MENDOCINO HISTORICAL REVIEW BOARD STAFF REPORT

JULY 1, 2019
MHRB_2016-0018

PROJECT DESCRIPTION: A Mendocino Historical Review Board Permit request to demolish, reconstruct, and/or construct the Ferro House, garage, tower, fencing, driveway and other structures. Note: Mendocino Town Plan Appendix 1 lists the site as a Category IIa Historic Resource.

STREET ADDRESS: 45270 Albion Street, Mendocino (APN: 119-217-06)

**HOUSE - NORTH ELEVATIONS -
EXISTING & PROPOSED**

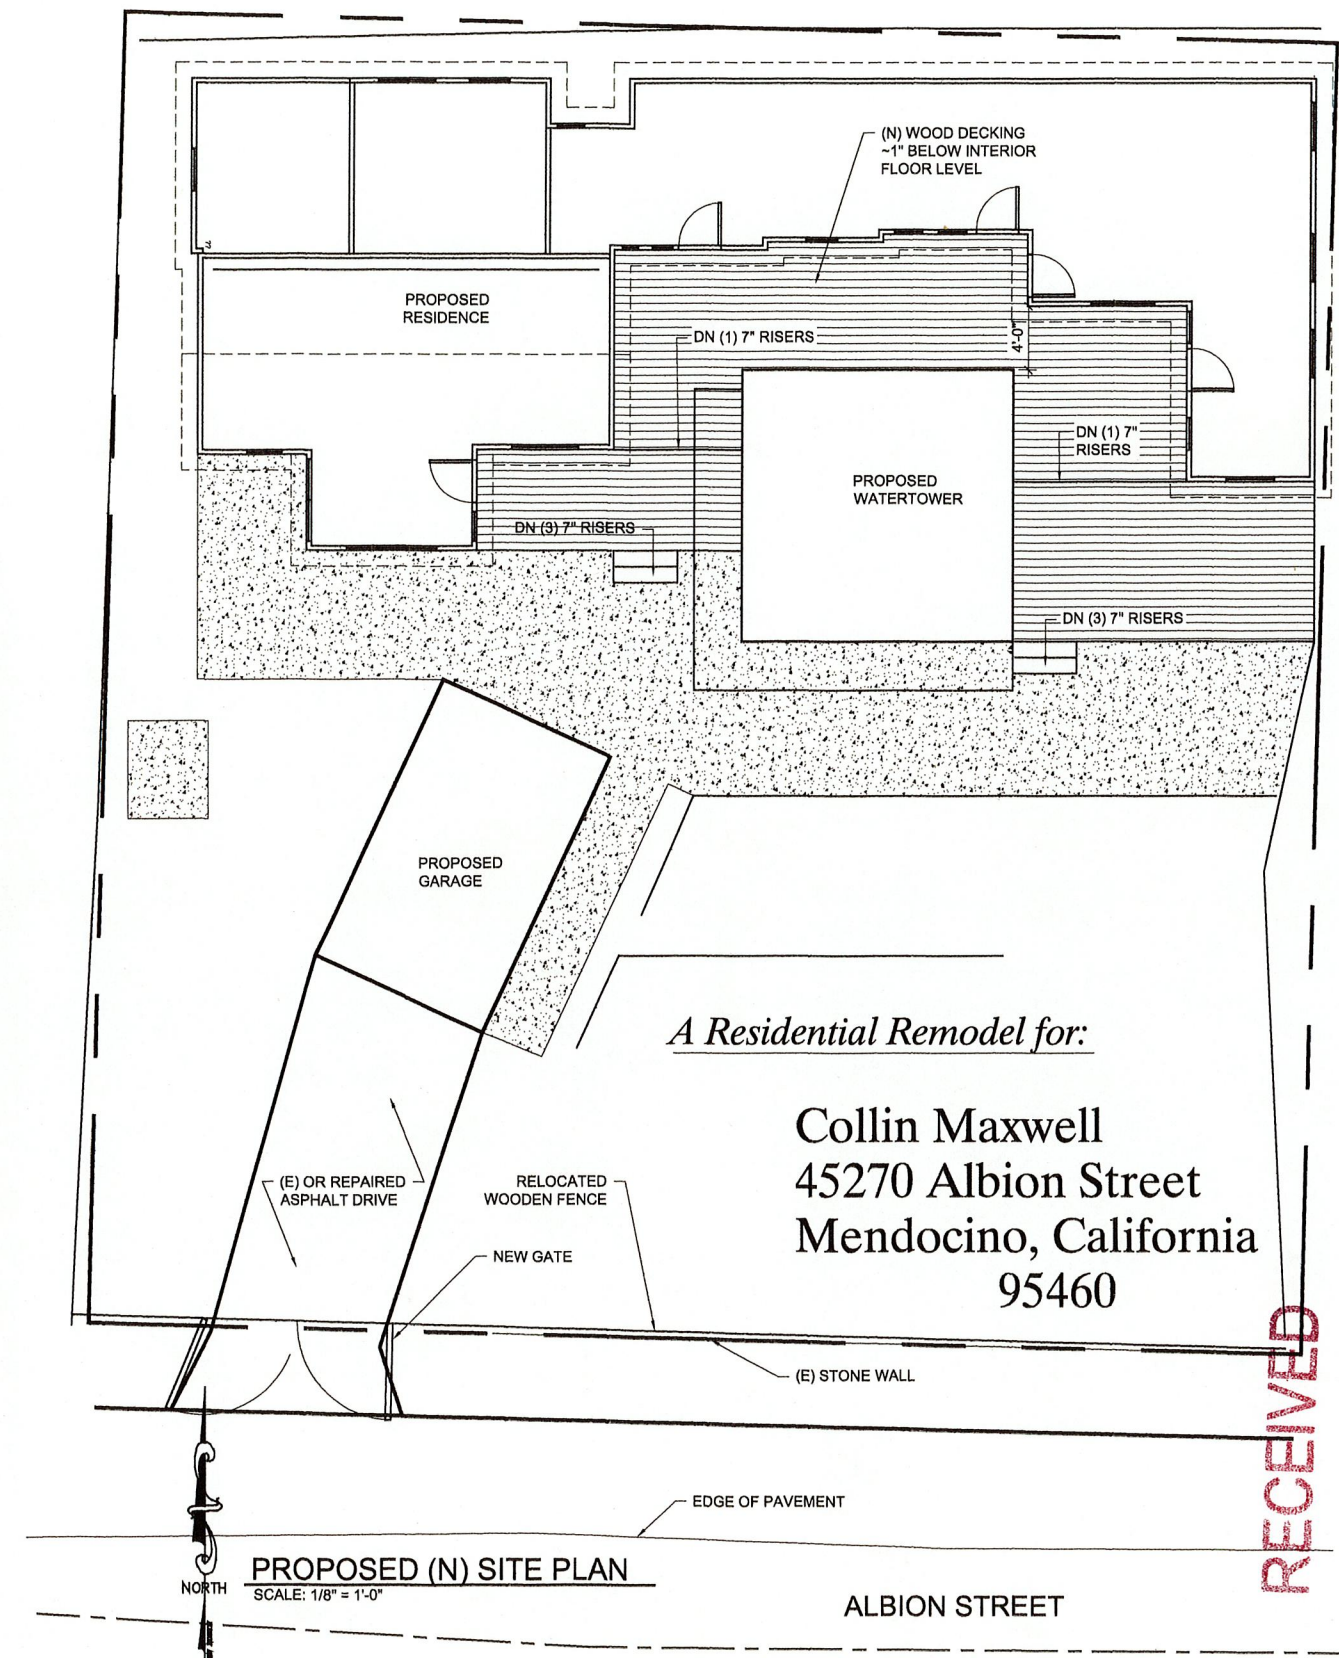
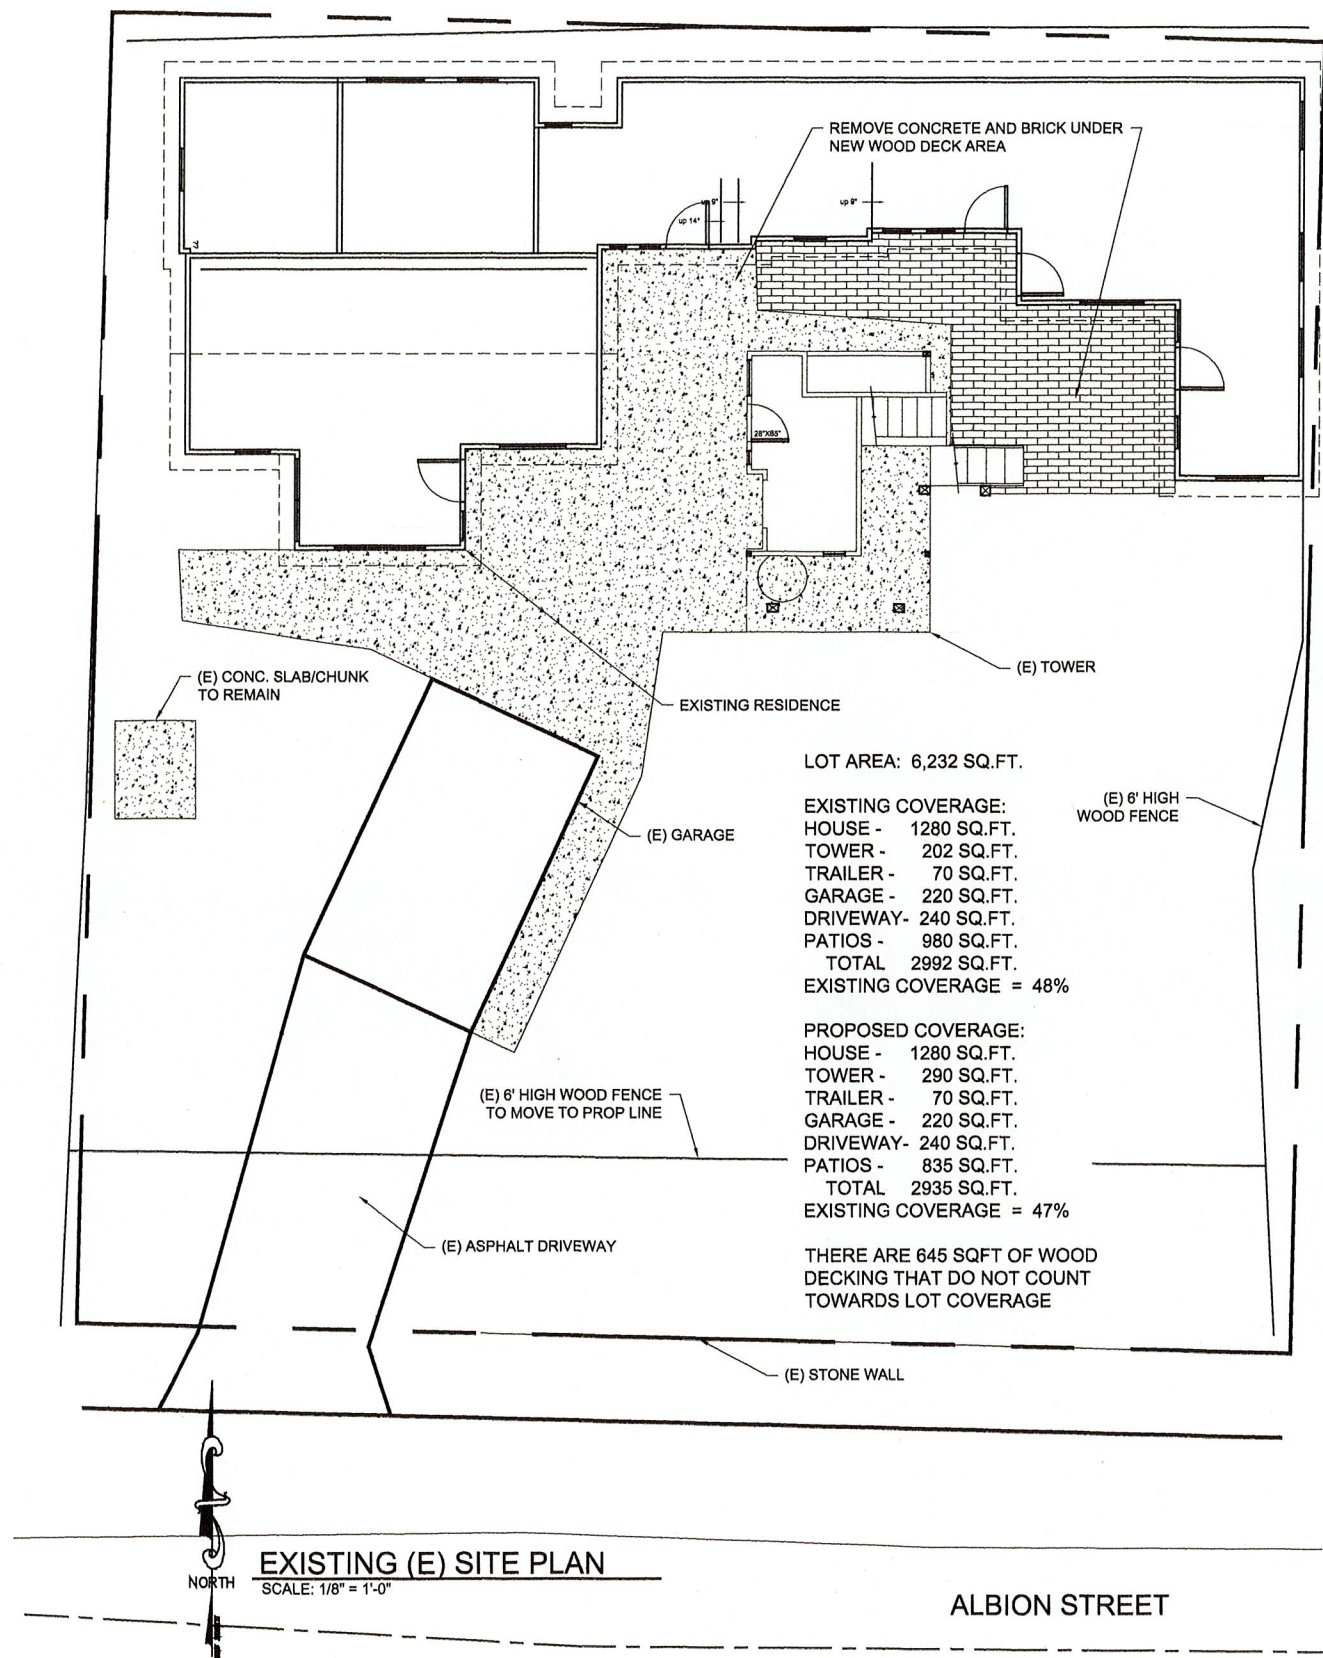
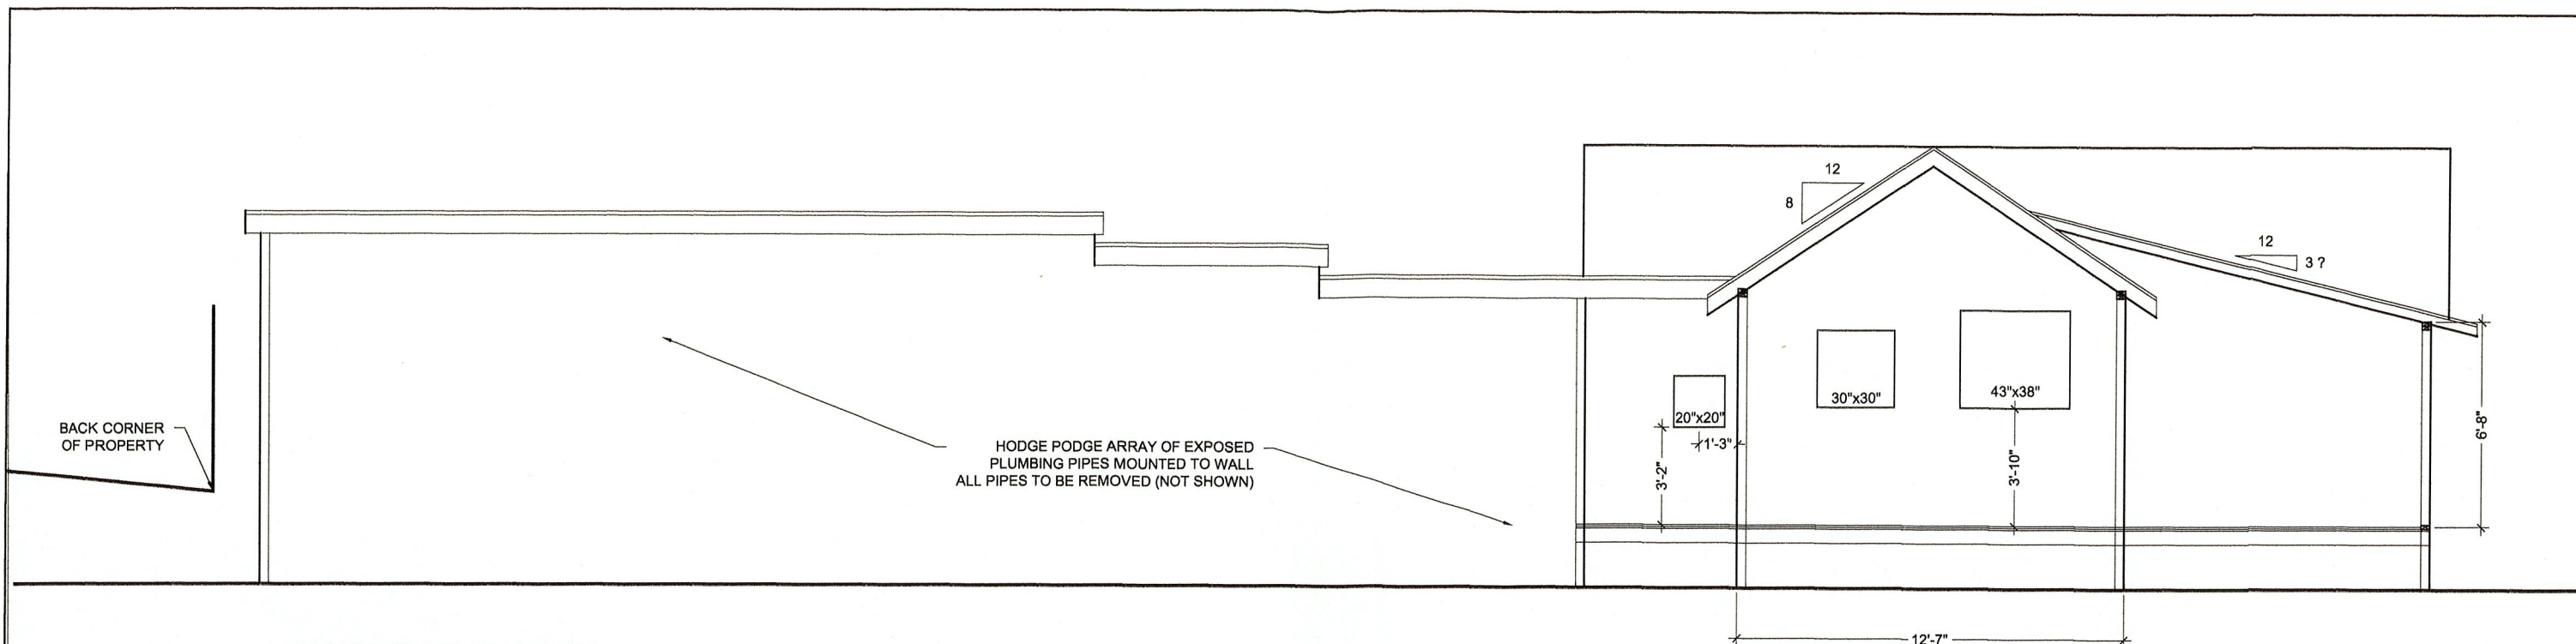
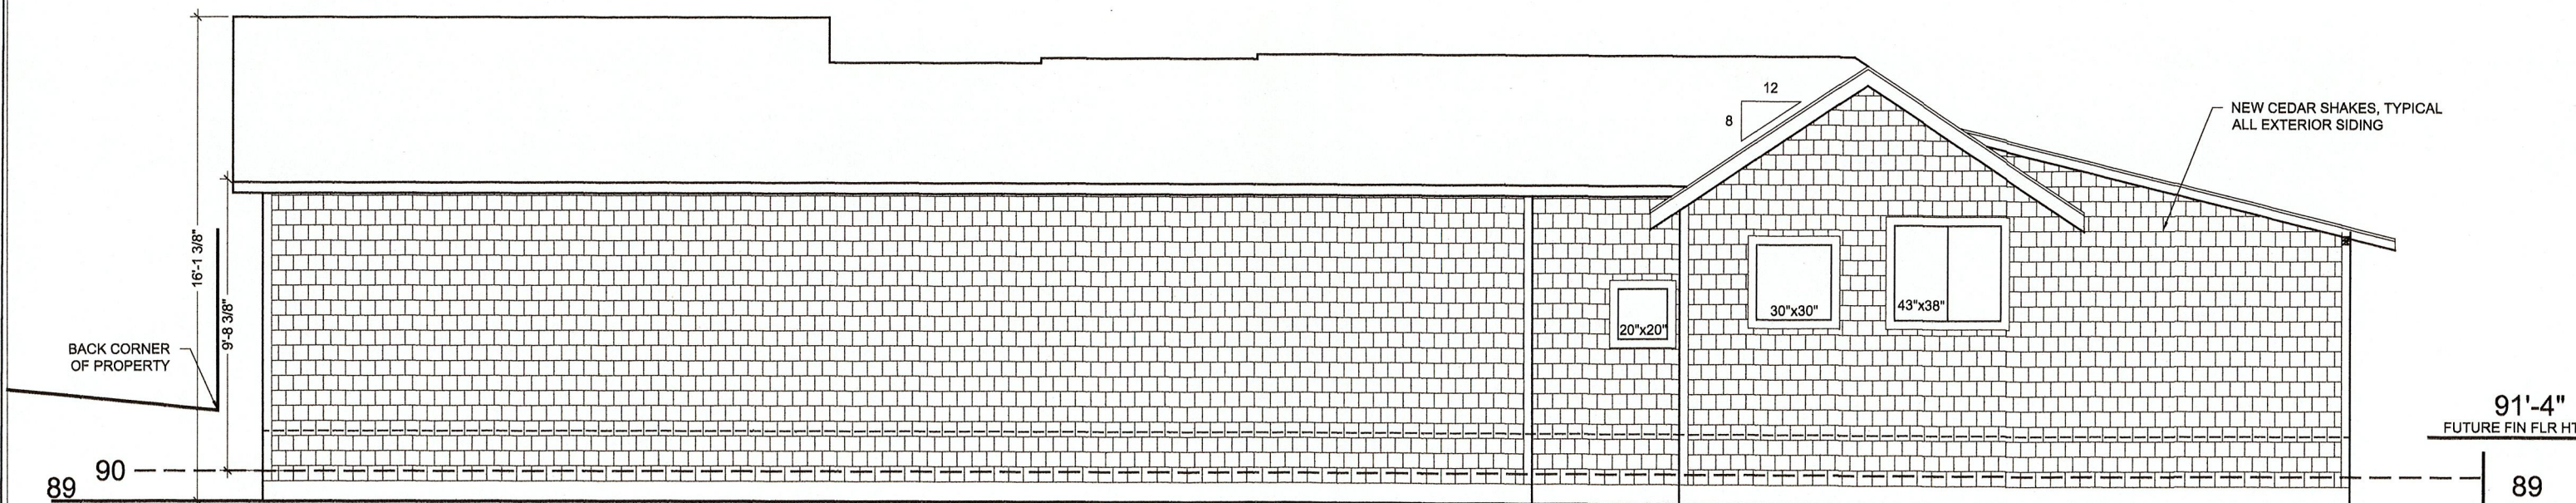
Proposed House Restoration and New Construction. The siding to the house (cabin, mudroom, additions) would be cedar shingles with oil finish to help preserve the material. Redwood trim would be painted forest green. The cabin, mudroom, and additions would be reconstructed in the existing foot print. The rooflines would be reconstructed with the same 8:12 pitch as shown on the as-built plans, except the circa 1980 addition with flat roofs would be rebuilt with a 8:12 pitched gabled roof running east west. Asphalt shingles would be used throughout. Existing windows would be replaced with wood-frame windows having mostly the same size, style, and shape. Windows would be placed within the proposed dormers. Doors would be replaced with painted fiberglass doors. See Sheet No.'s A2 through A5 for existing and proposed elevations of the house.

10. To the satisfaction of the Director of Planning and Building Services, exterior house building plans shall provide sufficient detail for the successful reconstruction of the cabin, mudroom, and additions with an 8:12 gabled roofline.
